## **ALERT SERVICE BULLETIN**

**407-24-134**  
12 February 2024

- MODEL AFFECTED:** 407
- SUBJECT:** Tailboom Attachment Hardware and Fittings, Inspection of
- HELICOPTERS AFFECTED:** Serial numbers 53000 through 53900, 53911 through 53999, 54000 through 54166, 54300 through 54752, 54805 through 54999 and 56300 and subsequent.
- COMPLIANCE:**
- PART I:** Within 50 flight hours or 30 days whichever occur first, following the release of this bulletin or if TB 407-17-125 is completed thereafter.
- PART II:** Within 50 flight hours or 30 days whichever occur first and every 300 flight hours thereafter following the release of this bulletin.
- PART III:** Within 50 flight hours or 30 days whichever occur first and every 50 flight hours thereafter following the release of this bulletin.

**Figure 1 - Tailboom Access Cover Removal/Installation**

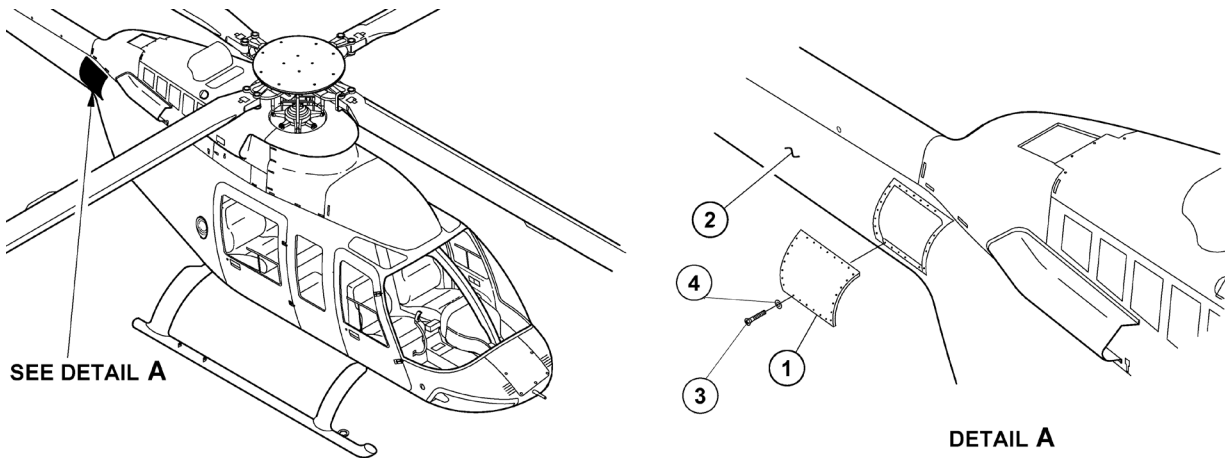
2. Remove tailboom access cover (1, Figure 1). Retain hardware for subsequent installation in later step.

4. Install the tailboom access cover (1, Figure 1).
5. Make an entry in the helicopter logbook and historical service records indicating compliance with **PART II** of this Alert Service Bulletin. Carry out the inspection and hardware replacement as described in **PART II** of this bulletin every 300 flight hours.

**Figure 2 – Upper Left Longeron 206-031-314-237  
“CAUTION COLD EXPANDED HOLE” decal**

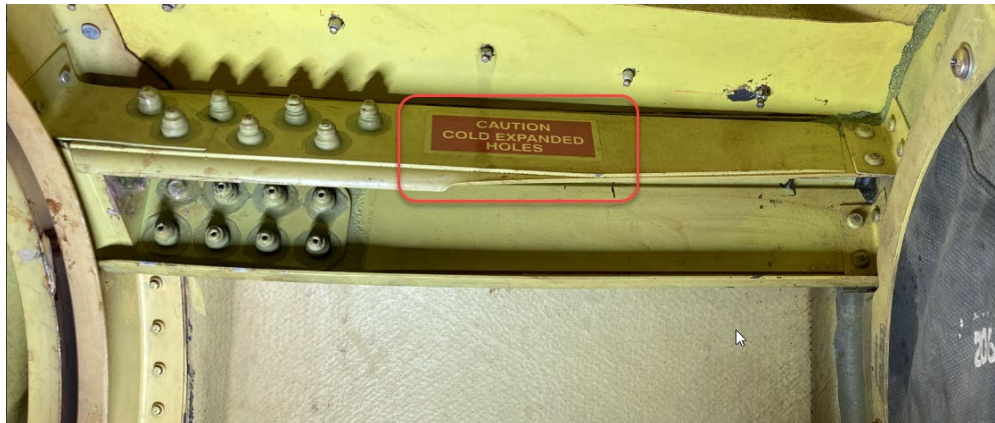
407 S/N: 53001 through 54061 did not have the 206-031-314-237 longeron assembly installed from factory with the "Caution Cold Expanded Holes" decal as shown in Figure 2. If the decal "Caution Cold Expanded Holes" is present on upper left longeron as shown in Figure 2 (Analog 407 prior to S/N: 54062), the longeron assembly was field replaced per the above Technical Bulletins.

**Figure 3 - Gap check at the upper left tailboom attachment interface with tailboom and hardware installed.**

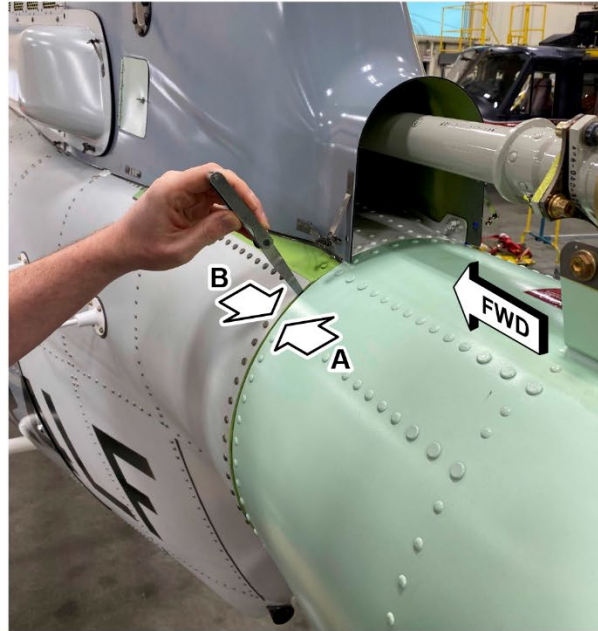
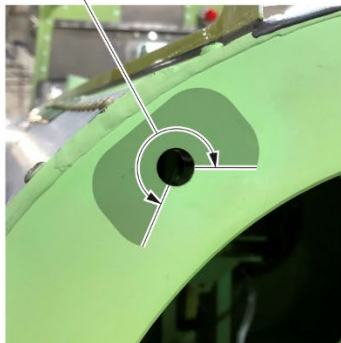
1. From the left side of the fuselage, using a strong light source and a feeler gauge, inspect for a gap at the upper left attachment interface between the aft fuselage and the tailboom. The entire tailboom forward bulkhead machined / hot bonded shim surface must be in contact with the aft fuselage bulkhead. Figure 3 shows the inspection area for possible gap between the machined / hot bonded shim and the

aft fuselage bulkhead. If a 0.003 inch (0.076 mm) feeler gauge or thicker can be inserted in the joint up to the bolt shank, contact Product Support Engineering for further instructions.

**Figure 4 Tailboom Attachment Hardware**

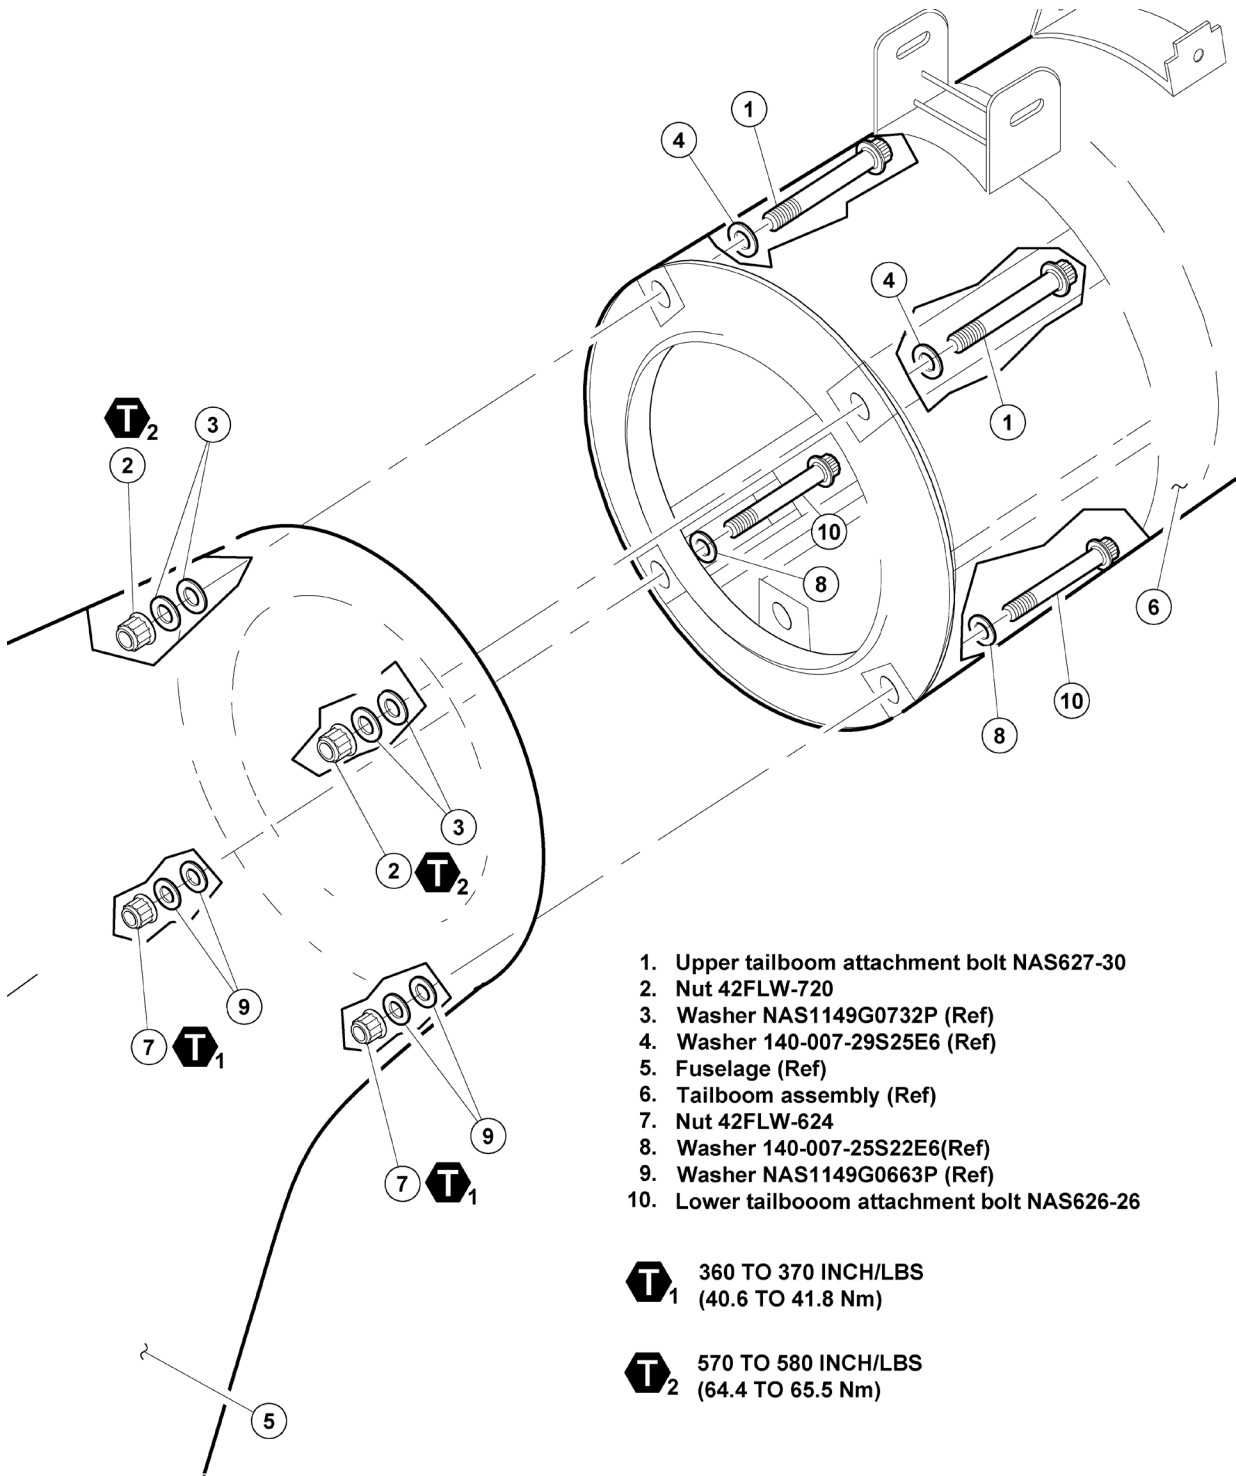
The torque values of the upper and lower nuts (2 and 7, Figure 4) are different. Refer to Figure 4 for the specified torque values.

For torque check purposes, the assembly torque to be applied is the minimum specified torque, plus the minimum acceptable tare torque of 14 inch-pounds (1.58 Nm) for the upper nuts and 9.5 inch-pounds (1.07 Nm) for the lower nuts (BHT-ALL-SPM, Chapter 2, Standard Practices Manual).

- e. Do a torque check of the 3 remaining tailboom to the aft fuselage attachment nuts (2 and 7, Figure 4) ([DMC-407-A-53-01-00-00A-720A-A](#)).
  - (1) If a nut fails the torque check, replace the affected bolt(s) and nut(s) with new bolt(s), nut(s), and washer(s) as applicable. Retain removed hardware for further investigation by Product Support Engineering.
    - (a) Refer to ([DMC-407-A-53-01-00-00A-720A-A](#)) for hardware installation procedures.
- f. After final torque is applied, apply corrosion preventive compound (C-586) to the head of the bolt, washers, nut, and the exposed threads.
- g. After 1 to 5 flight hours, perform the Tailboom Attachment Hardware Torque Check special inspection at every location where new hardware was installed

5. Do a torque check of the tailboom to the aft fuselage attachment nuts (2 and 7, Figure 4) ([DMC-407-A-53-01-00-00A-720A-A](#)).
  - a. If a nut fails the torque check, replace the affected bolt(s) and nut(s) with new bolt(s), nut(s), and washer(s) as applicable. Retain removed hardware for further investigation by Product Support Engineering.
